**UNION COUNTY PUBLIC LIBRARY  
LIBRARY RENOVATIONS AND ADDITION**

**LWC Commission No. 22110.00**

**ADDENDUM #08  
DECEMBER 13, 2023**

**PLUMBING PLAN - FOUNDATION LEVEL - NEW WORK**

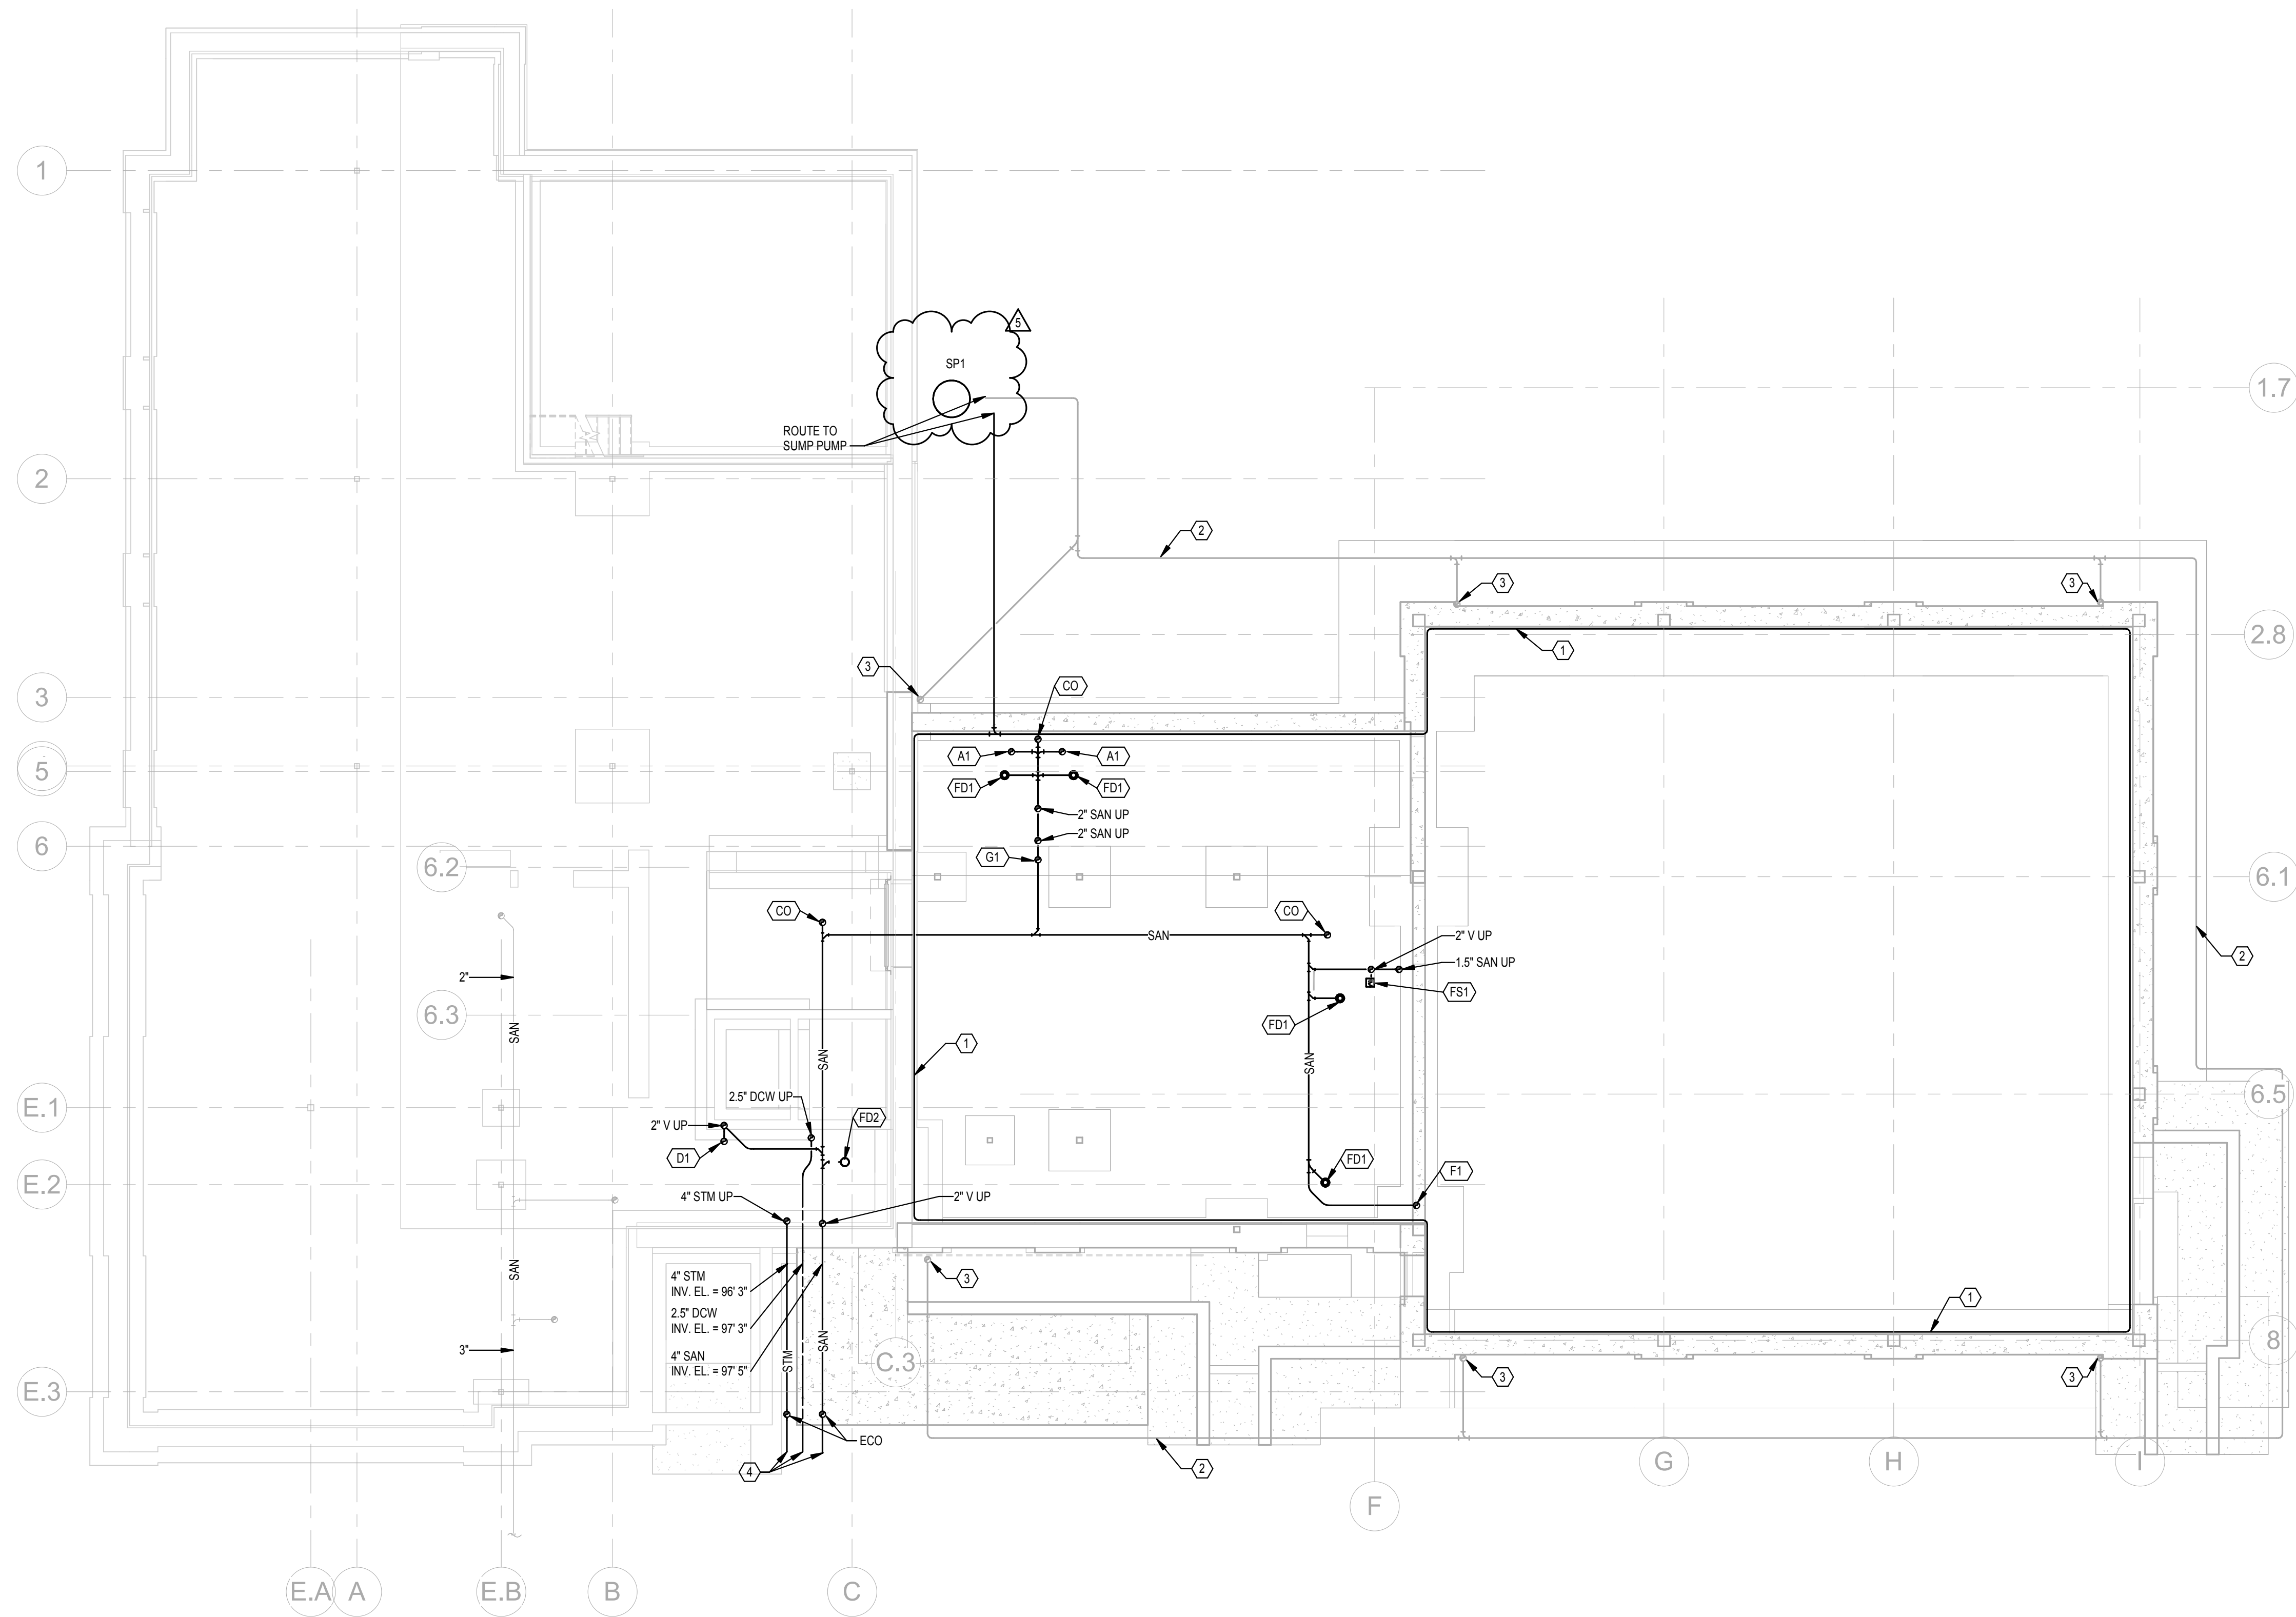
ITEM NO.1 – P200 – Plumbing Plan – Foundation Level – Work

- Added sump pump
